GOVERNMENT OF THE DISTRICT OF COLUMBIA
DEPARTMENT OF CONSUMER AND REGULATORY AFFAIRS
OFFICE OF THE ZONING ADMINISTRATOR

June 16, 2017

Re: Square 982, Lot 70 (the "Property")

File: Det Let re 1107 H St NE to Moldenhauer 6-16-17

ZA-2

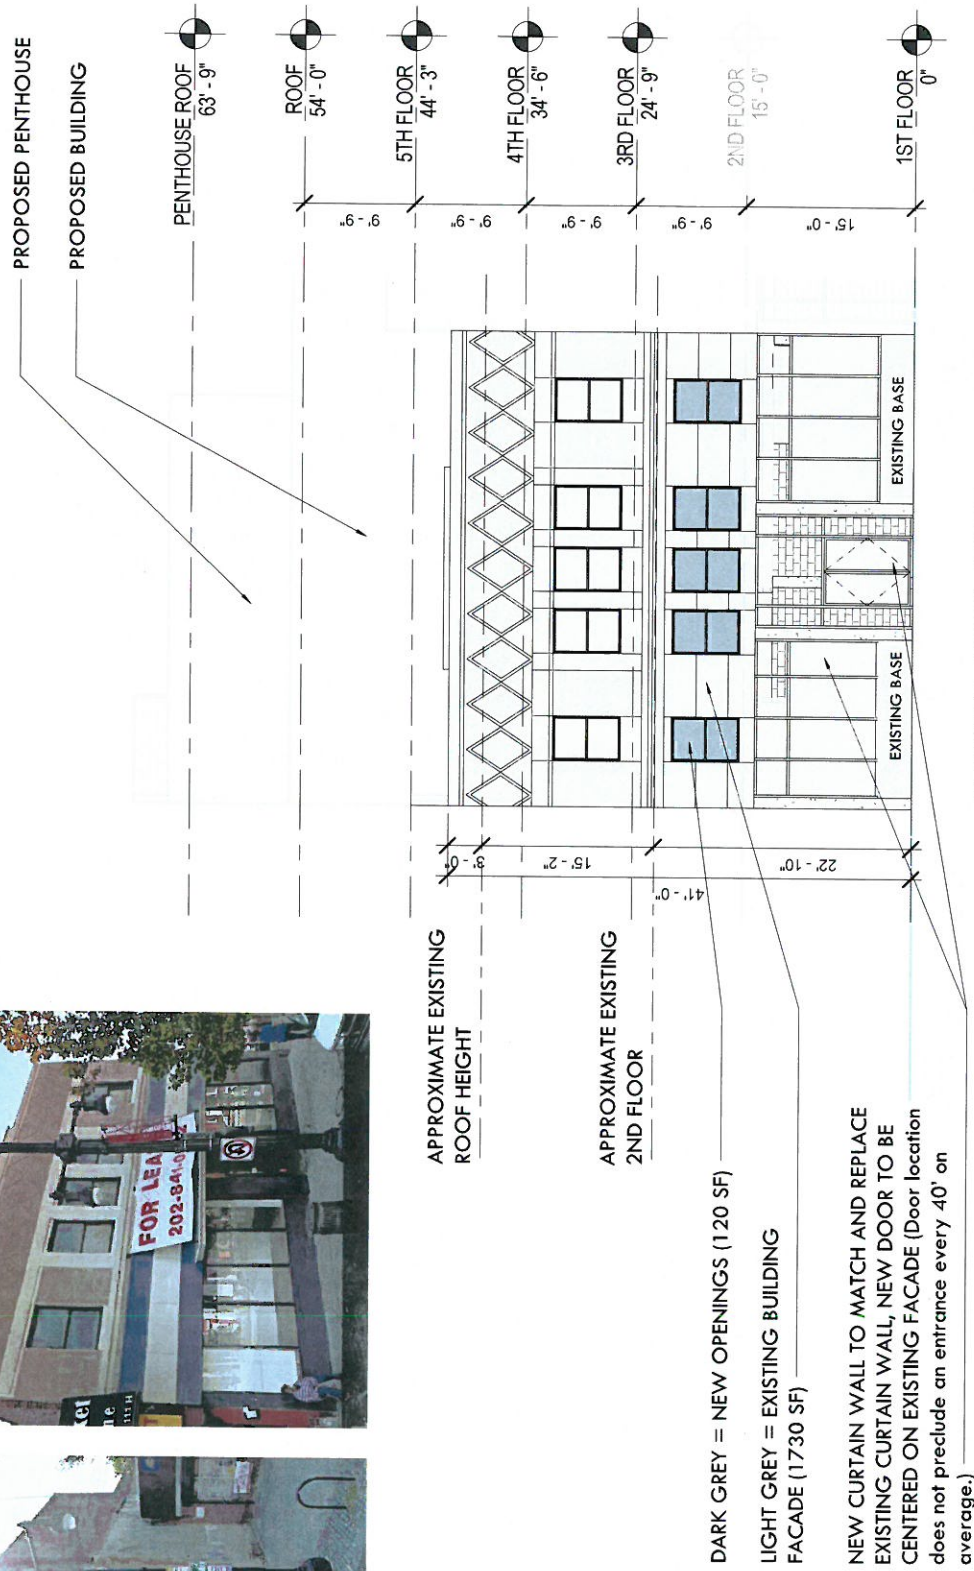
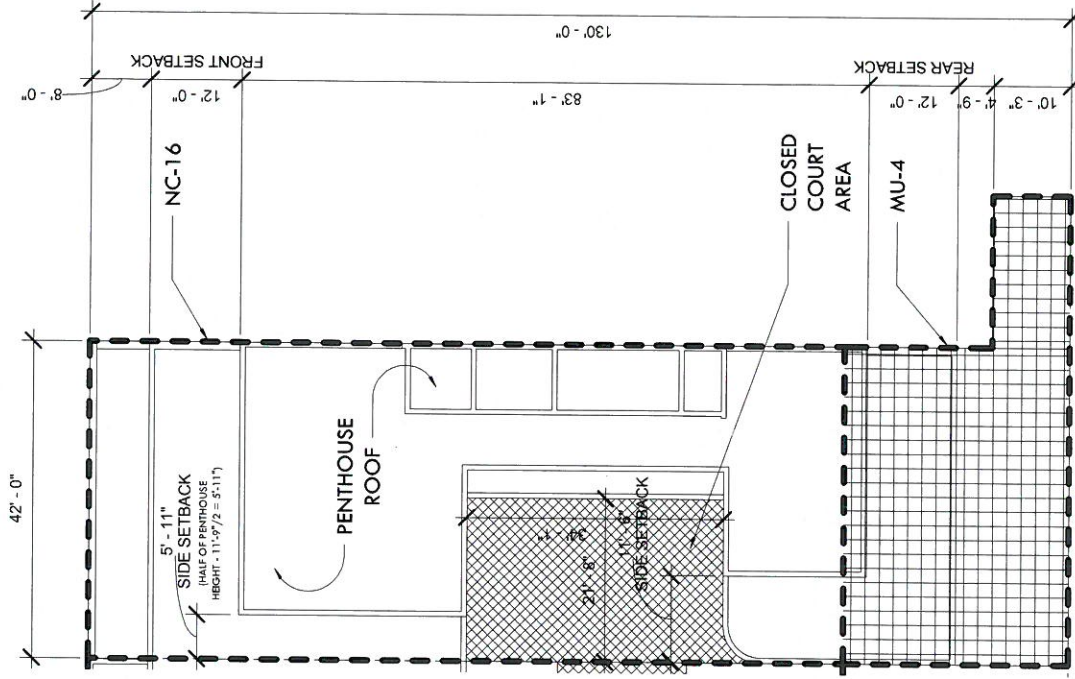
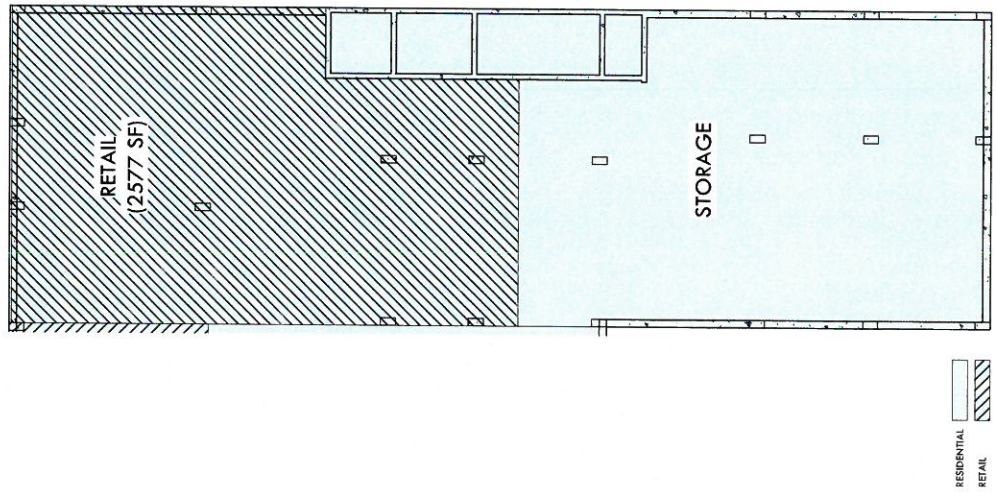
Court Area: Furthermore, pursuant to Subtitle H § 907.1, the minimum area of a closed court is "twice the square of the required width of court dimension." Accordingly, the minimum closed court area is 450 s.f. (15-foot width x 15-foot width x 2). In this case, as shown in the Site Plan at Sheet ZA-2 of **Tab "B"**, the Project provides a closed court that is 742 s.f. in size, which is more than the required minimum area. Accordingly, the Project satisfies the zone's closed court requirement.

As shown on Sheets ZA-2 and ZA-6 of **Tab “B”**, the proposed penthouse will satisfy the penthouse setback requirements of Subtitle C § 1502.1(a), (b) and (c). The 11-foot-9-inch habitable penthouse will be set back 12 feet from the front and rear building walls of the roof upon which it is located, as required by Subtitle C §§ 1502.1(a) and (b). No side setback is required from the east roof wall (adjacent to Lot 57) because the Property adjoins another building with an equal permitted matter-of-right building height. See Subtitle C § 1502.1(d). A 1: ½ side setback is required from the west roof wall (adjacent to Lot 65) pursuant to Subtitle C §§ 1502.1(d). As shown on Sheets ZA-2 and ZA-6 of **Tab “B”**, the penthouse provides a west side setback of 5 feet-11 inches, in satisfaction of that requirement.

The NC-16 and MU-4 Zone Districts both require a minimum 15 foot rear yard. Subtitle H § 905.1; Subtitle G § 405.2. The Project provides a 15-foot-2-inch rear yard, as shown on Sheet ZA-2, thus meeting the rear yard requirements of both zones.¹²

¹² As shown on sheet ZA-2, on the ground level, the rear yard is 27 feet-2 inches in length. The Project includes an approximately 12-foot projection into the rear yard area on floors two to five. This projection is permissible because there remains 15 feet-2 inches of rear yard that is “open to the sky from the ground up”.

ZA-7

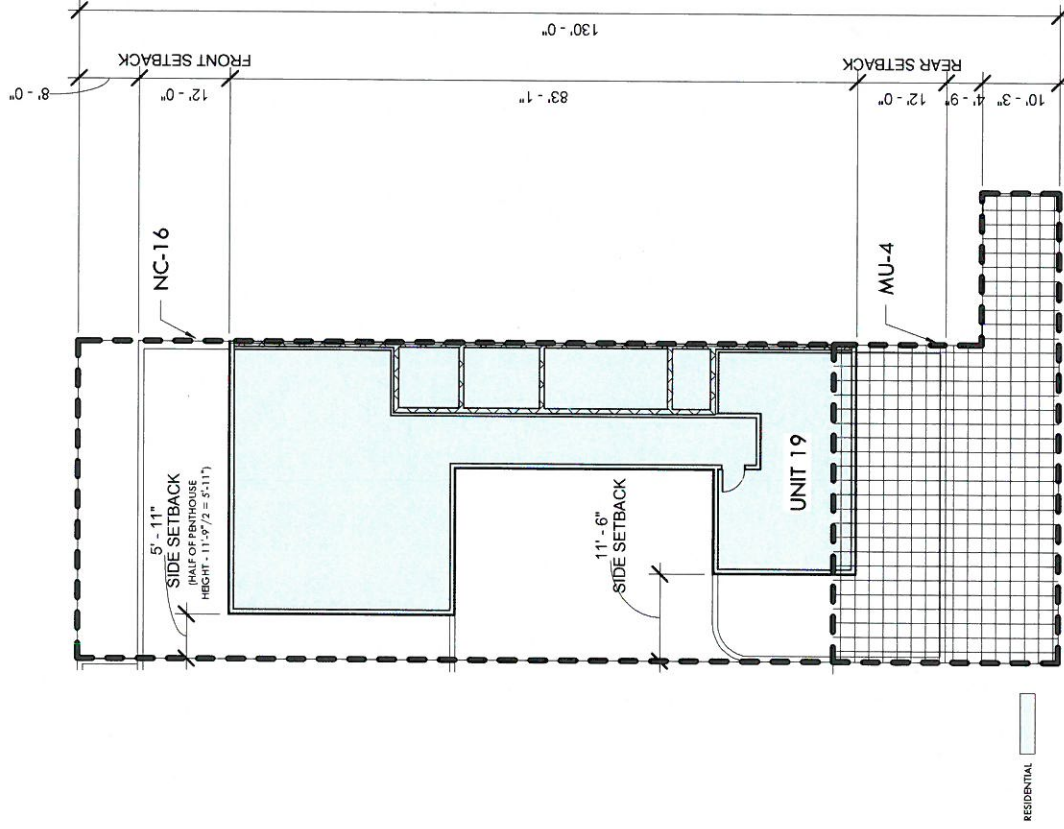
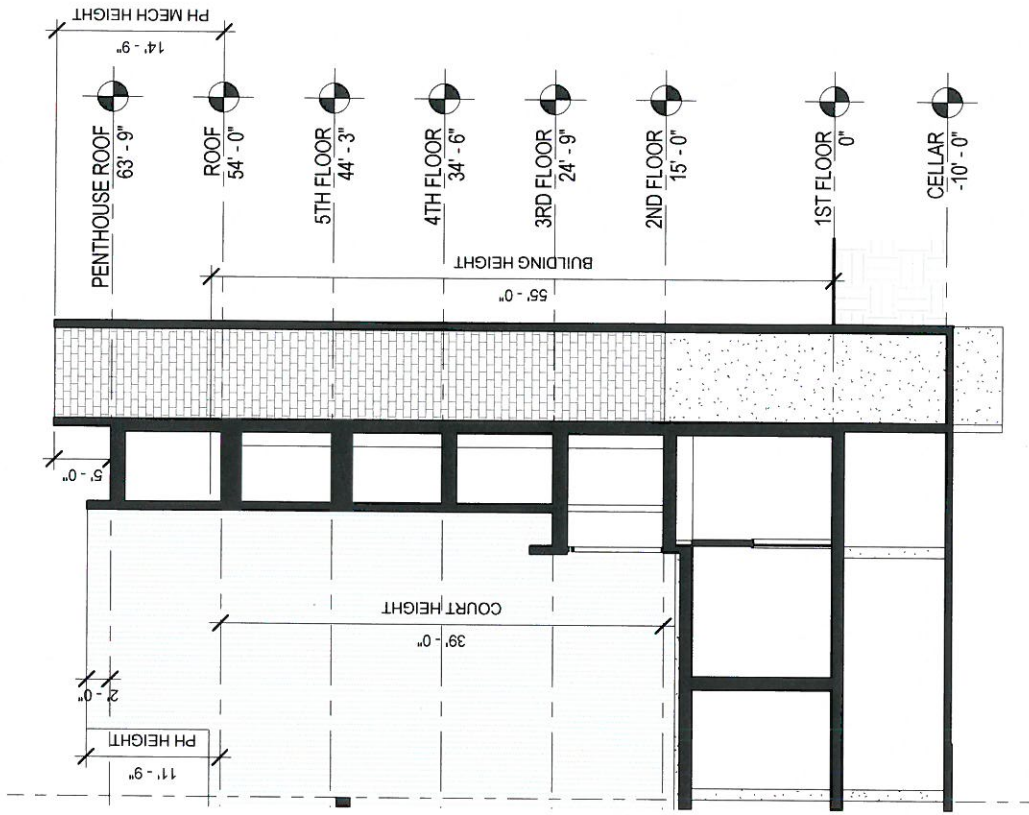
The Project fronts on H Street and proposes a ground-floor level with a uniform minimum clear floor-to-ceiling height of 15 feet, as shown on Sheets ZA-1B and ZA-7 at **Tab "B"**.⁹ Accordingly, the maximum permissible height for the Project is 55 feet. The elevations on Sheet ZA-7 illustrate that the Project would have a maximum height of 54 feet. Accordingly, the Project satisfies this requirement.

Here, because the court begins on the second floor and ends on the fifth floor, the bounding walls of the court are approximately 39 feet in height (Roof elevation of 54 feet – 2nd Floor elevation of 15 feet), as shown on Sheet ZA-7. Therefore, the minimum width of the court is 15 feet ($39 \text{ feet} \times 4/12 = 13 \text{ feet}$, which is less than 15 feet). As shown in the Site Plan at Sheet ZA-2 of **Tab "B"**, the court has a minimum width of 21 feet-6 inches. Accordingly, the court satisfies the zone's minimum width requirement for a closed court.

As shown in the elevation on Sheet ZA-7 of **Tab “B”**, the Project proposes an 11-foot-9-inch tall, habitable penthouse with an approximately 3-foot-tall story for penthouse mechanical space. Accordingly, the penthouse’s maximum height of 14 feet-9 inches satisfies the requirement for the zone.
